**Subject: 80 Lake Street  
Response to Comment Letter**

On behalf of Jim Wu, Terradyn Consultants, LLC is pleased to submit responses to staff comments on the Site Plan application for the 80 Lake Street project. The information enclosed was prepared in response to the staff review comments provided on April 12, 2024.

### **Comments from Katherine Cook, Planning Coordinator, Dated April 12, 2024:**

PROJECT: LAKE STREET SCHOOL APARTMENTS  
 80 LAKE STREET, AUBURN, MAINE  
 SHEET TITLE: FIRE TRUCK TURNING PLAN  
 CLIENT: JIM WU  
 279 CENTER STREET  
 AUBURN, MAINE 04210  
 DATE: 4/3/2024  
 SCALE: 1"=20'  
 JOB NO: 23-75  
 SHEET: C-2.0

PROJECT: LAKE STREET SCHOOL APARTMENTS  
80 LAKE STREET, AUBURN, MAINE  
SHEET TITLE: SITE LAYOUT PLAN  
CLIENT: JIM WU  
279 CENTER STREET  
AUBURN, MAINE 04210

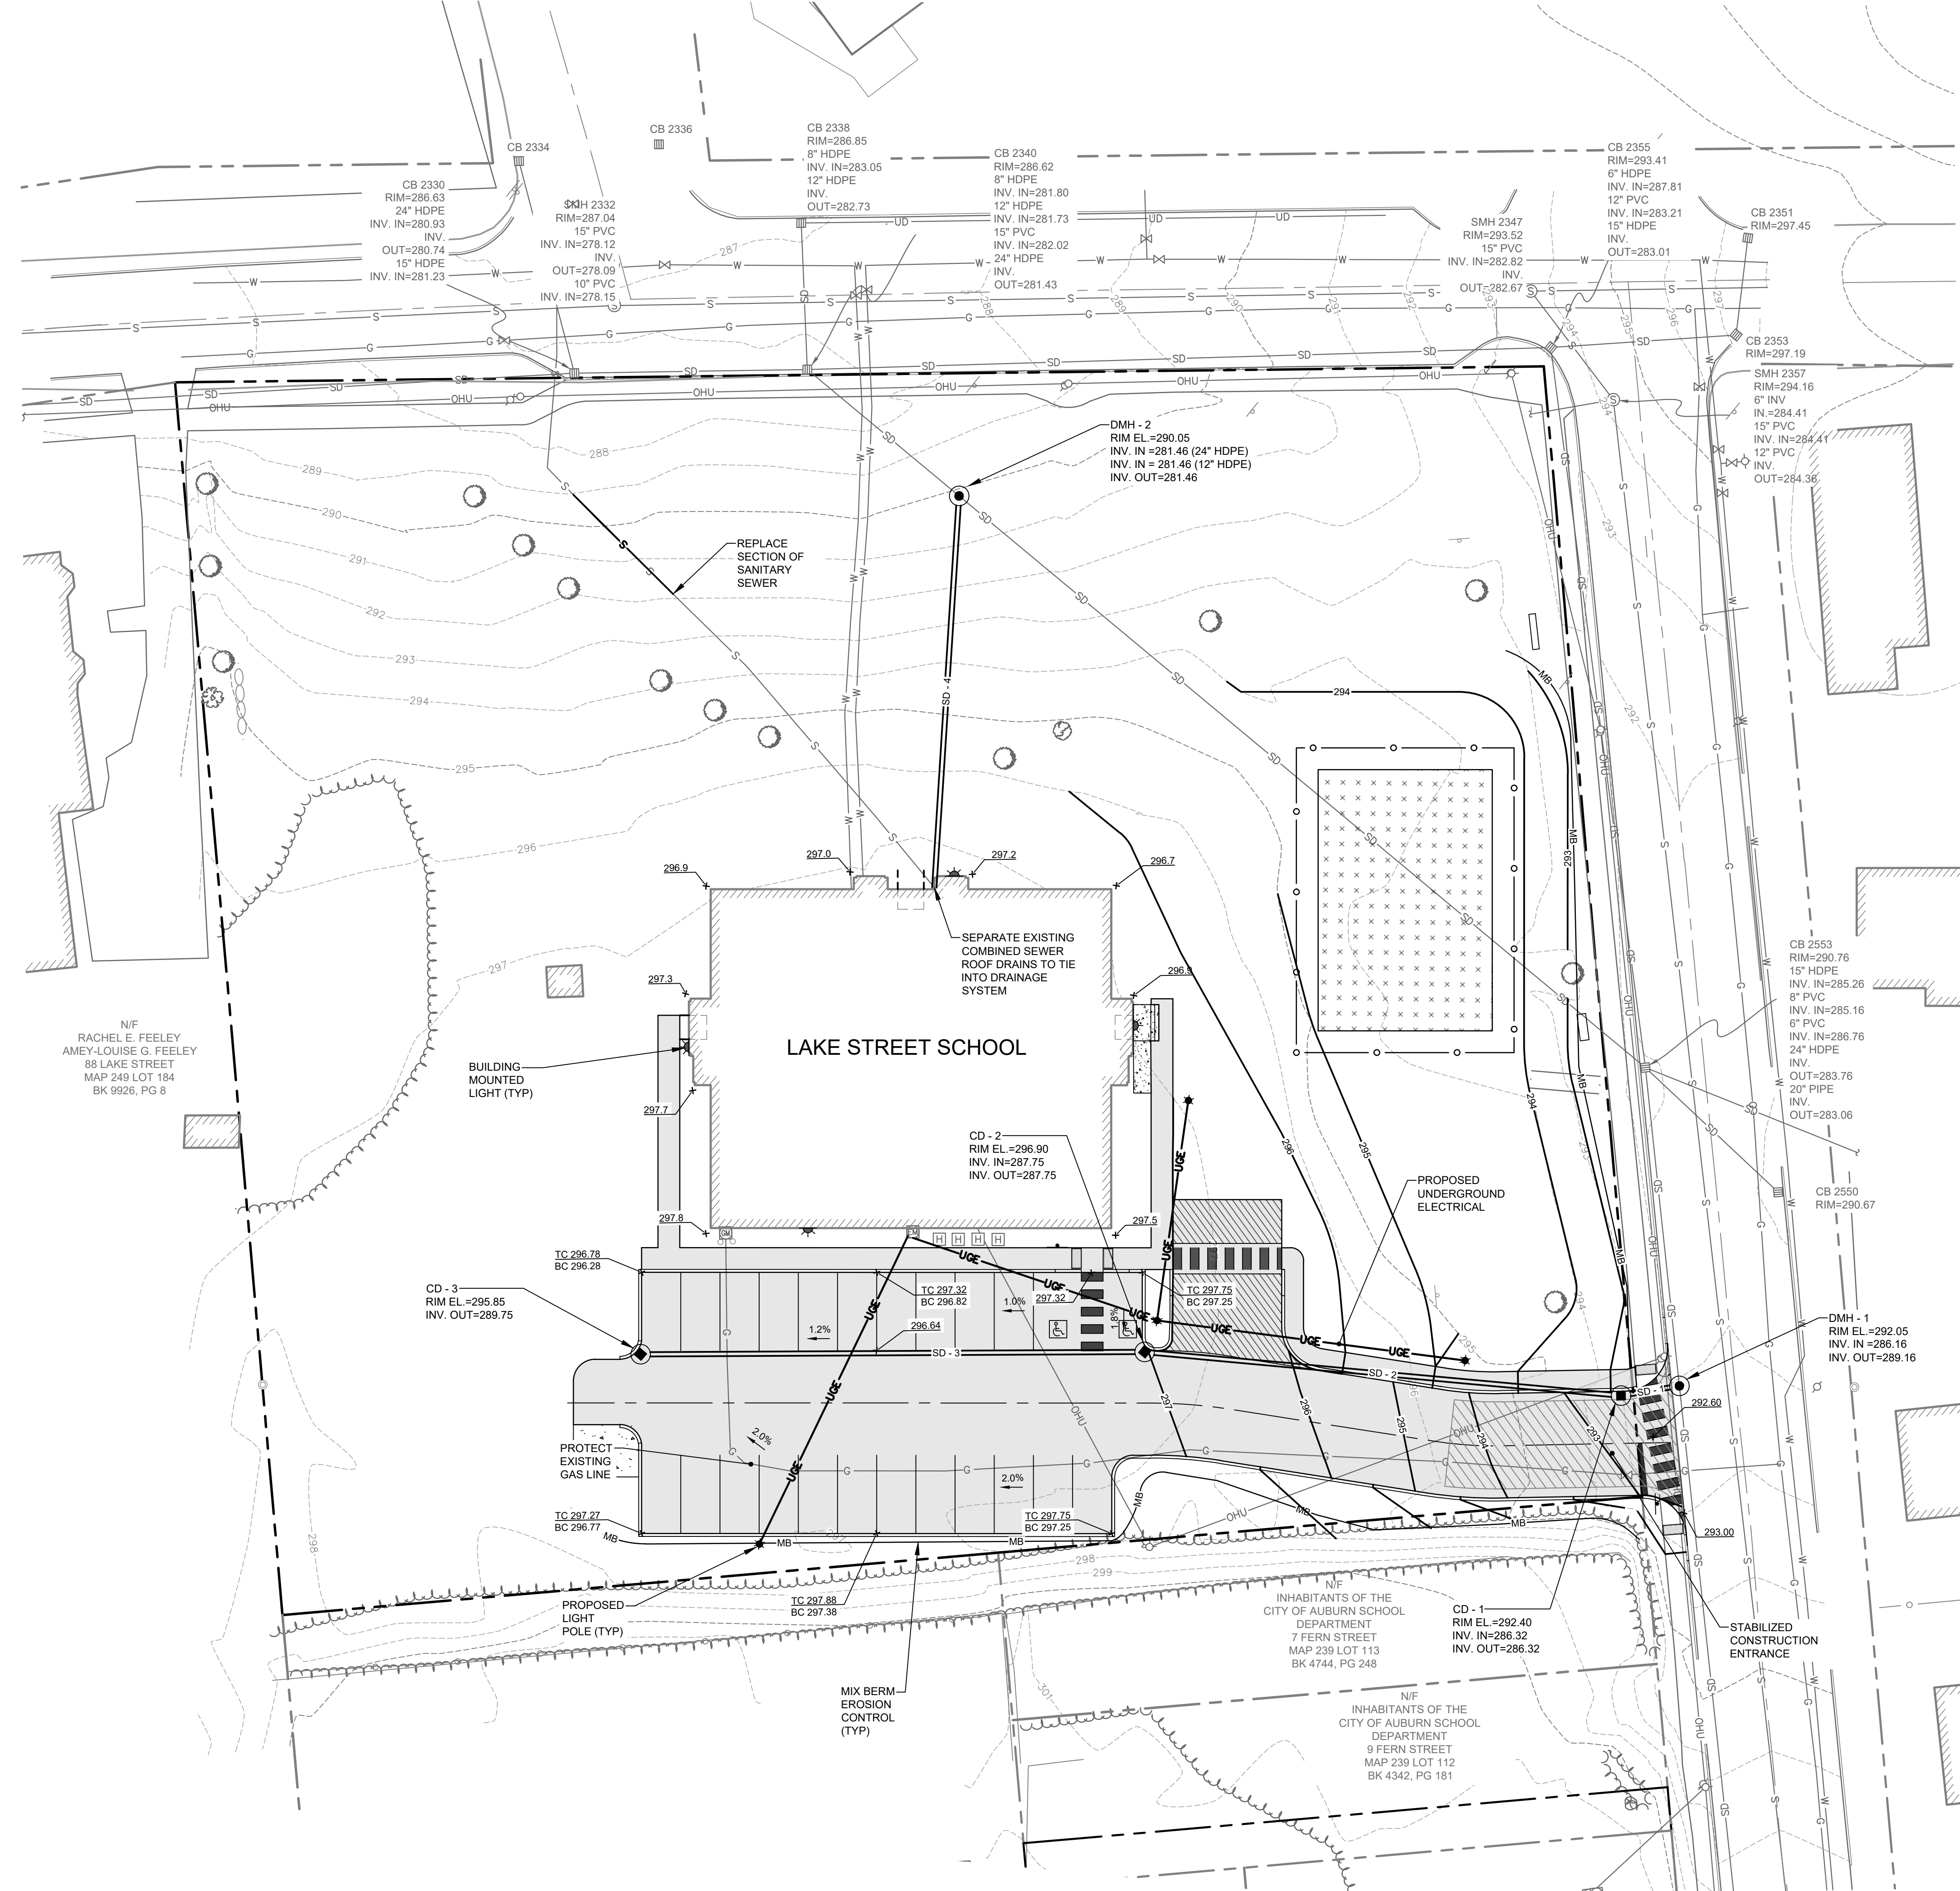
3. *It appears that the public conservation easement area may be a little off from where the City believes it is.*

5. *It appears that with the dumpster's placement, there is no place to push snow. Please address this item.*

**Comment Response:** The public conservation easement has been updated to reflect a 200' x 80' easement area on the plans.

**Comment Response:** The dumpster location has been adjusted; additional information is shown on the attached plans.

SHEET TITLE: GRADING & UTILITY PLAN

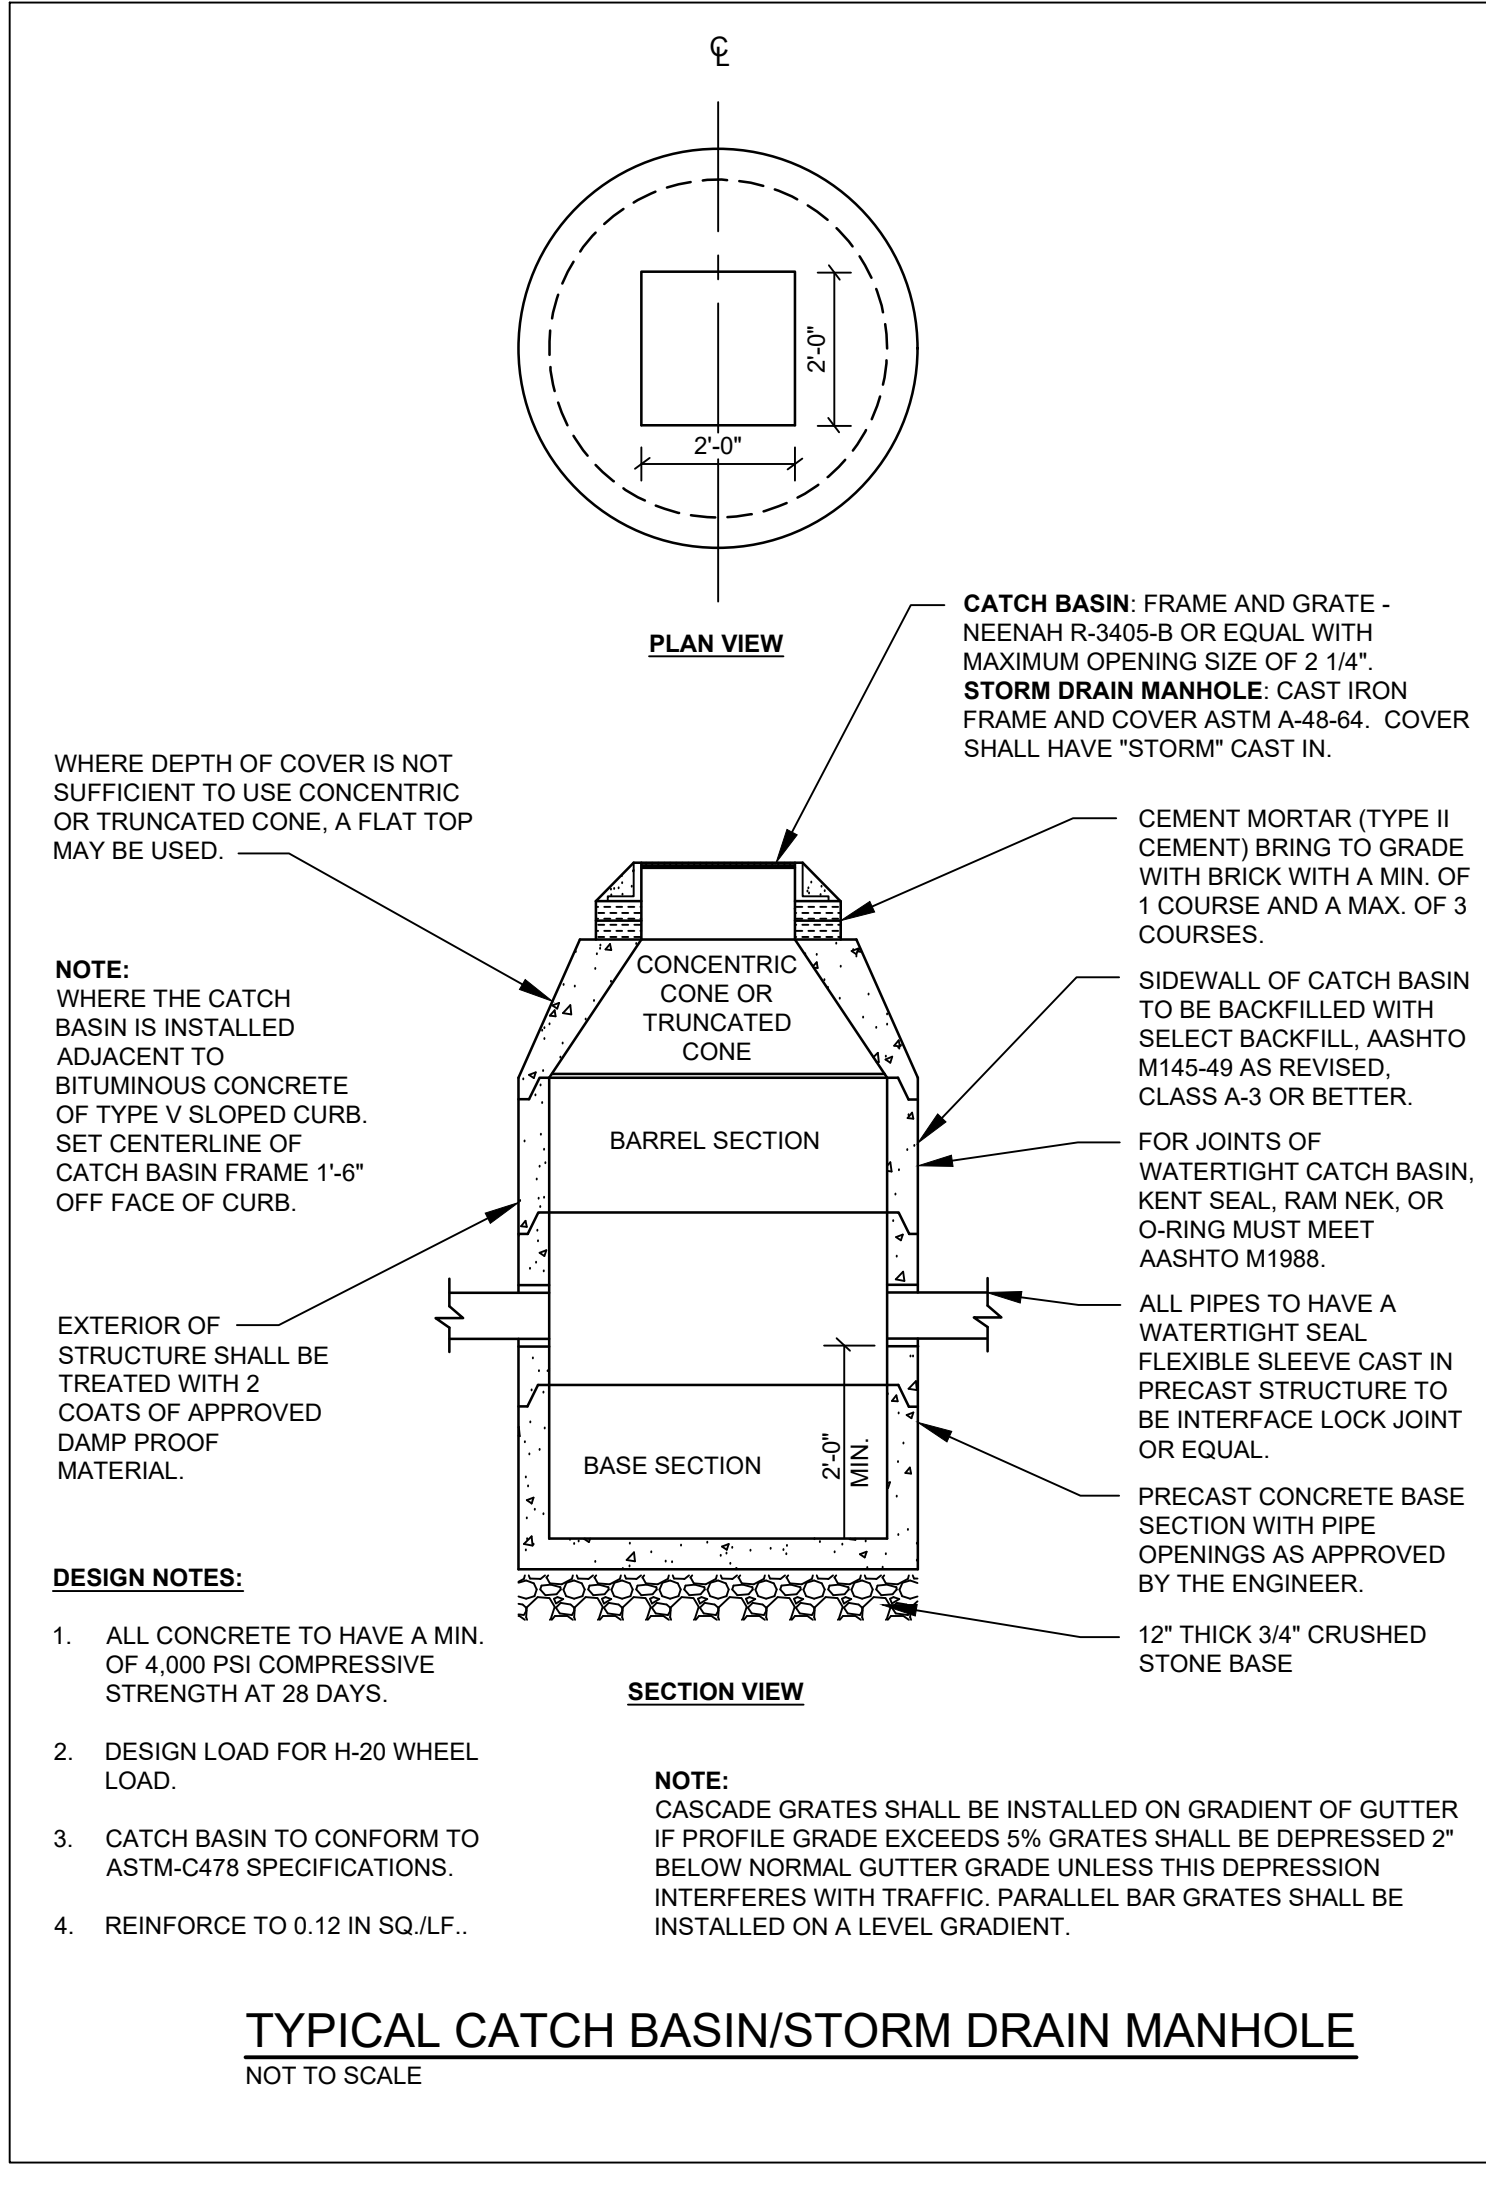
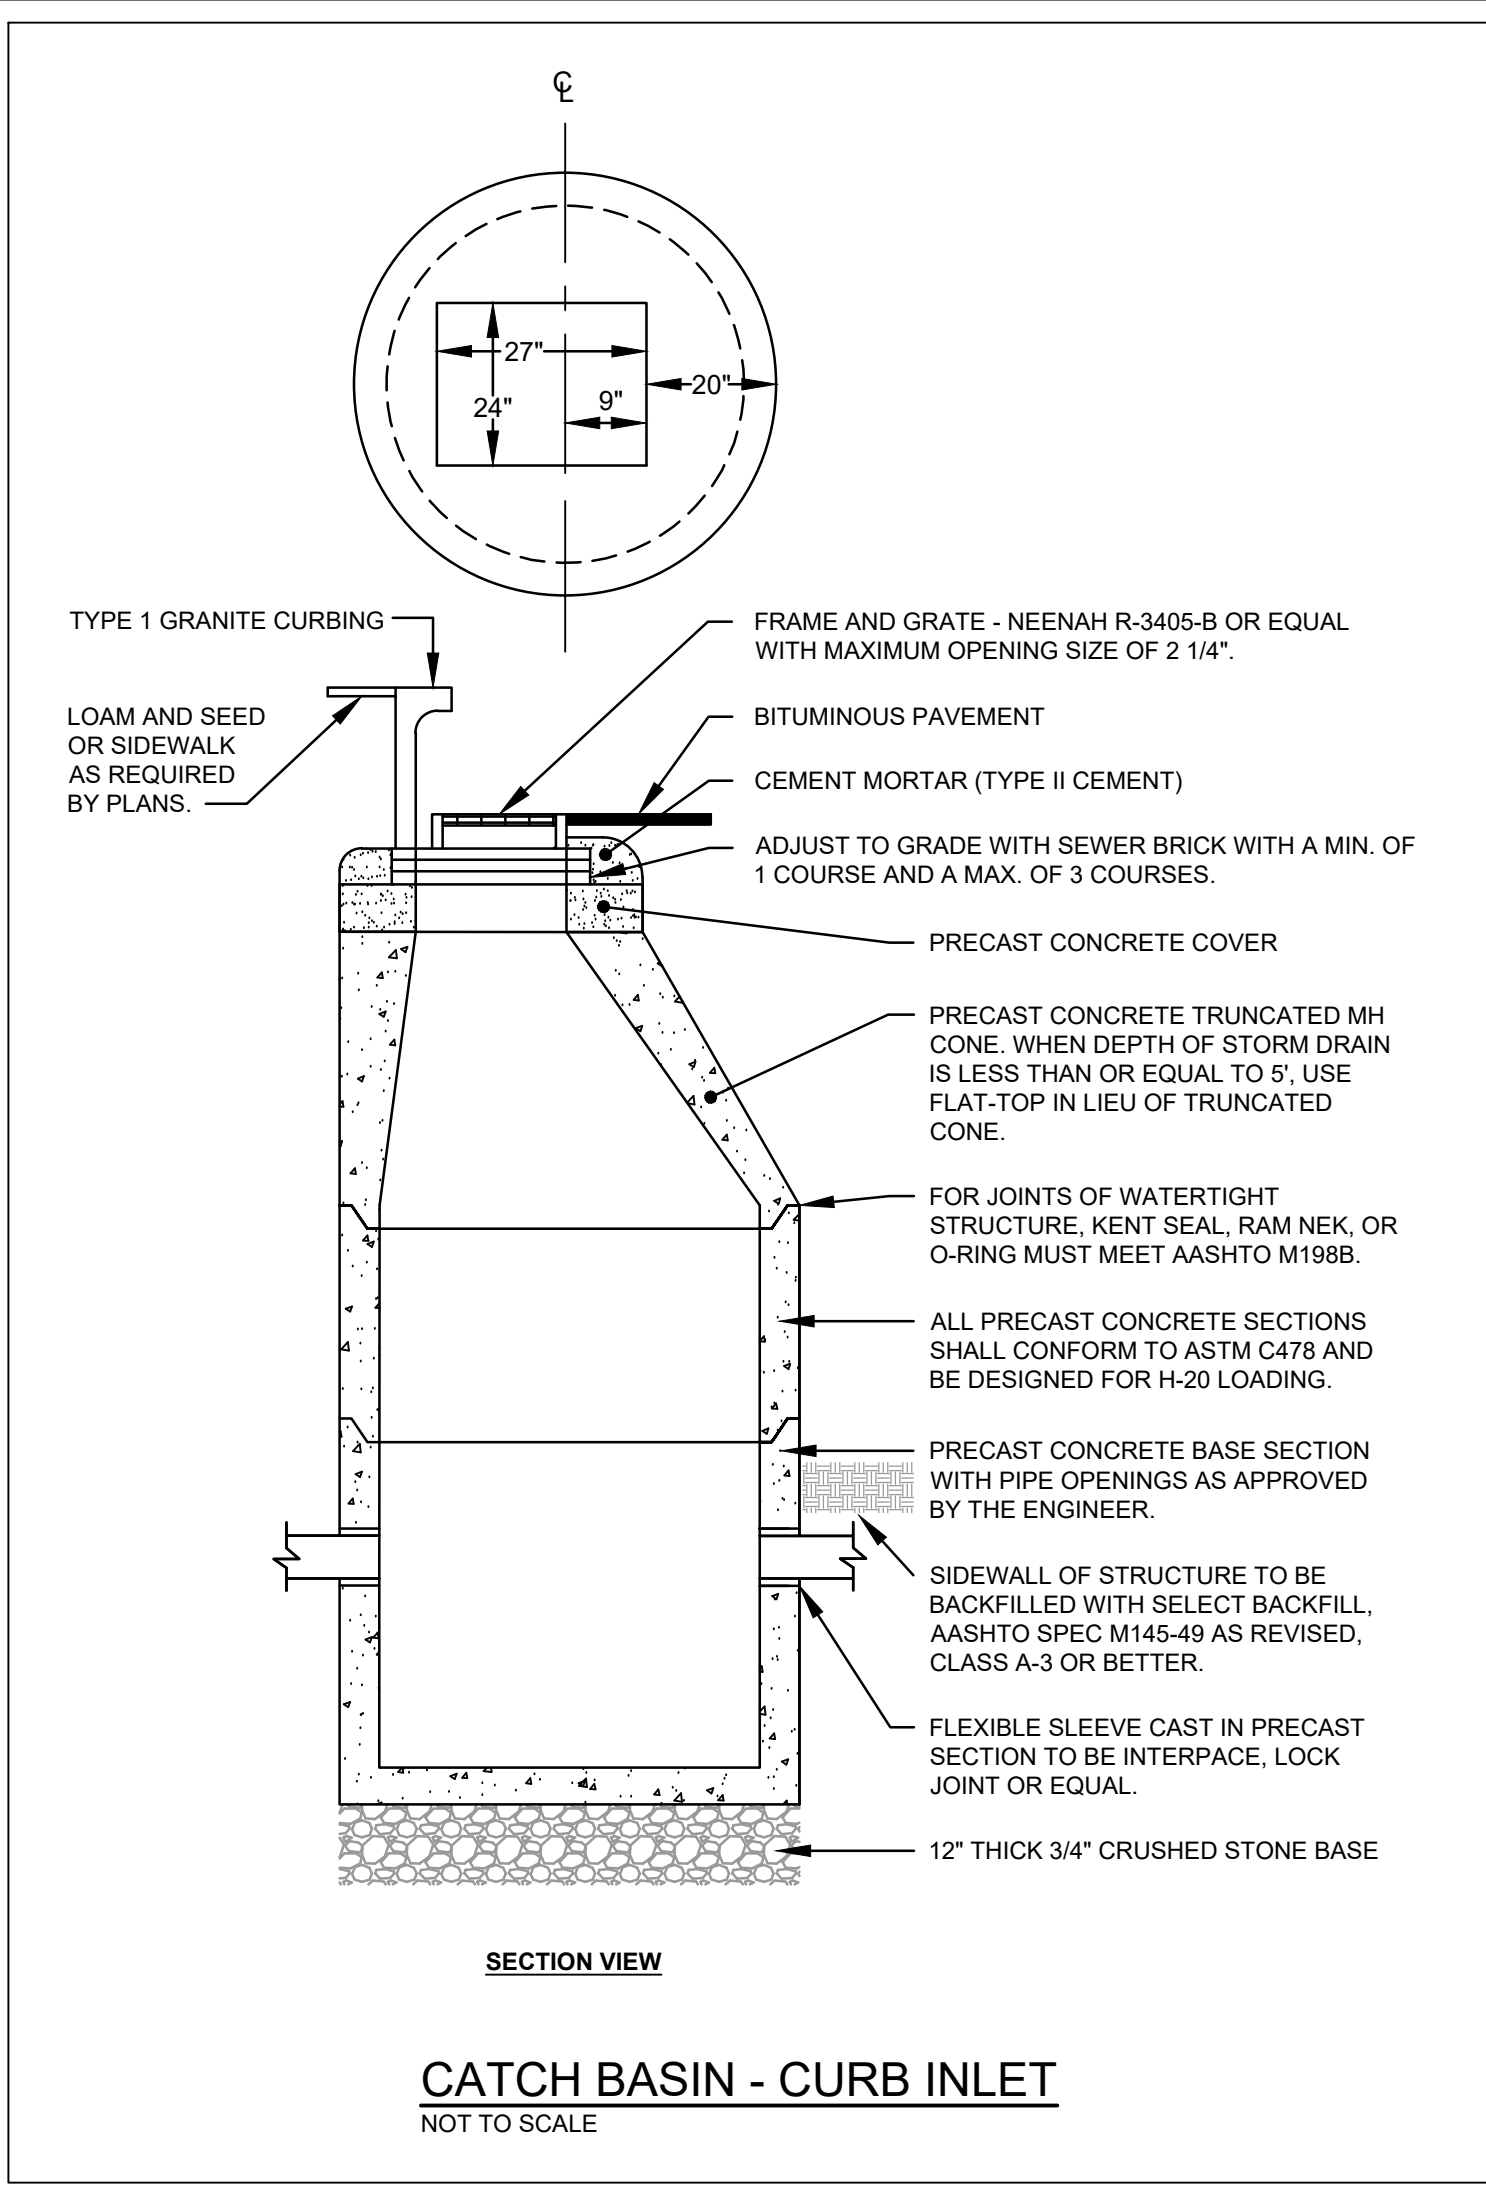
1. *All roof drains tied into the sewer must be removed.*

**Comment Response:** The roof drains that currently tie in the sanitary sewer will be separated as part of the proposed development; please see the attached plans for additional information.
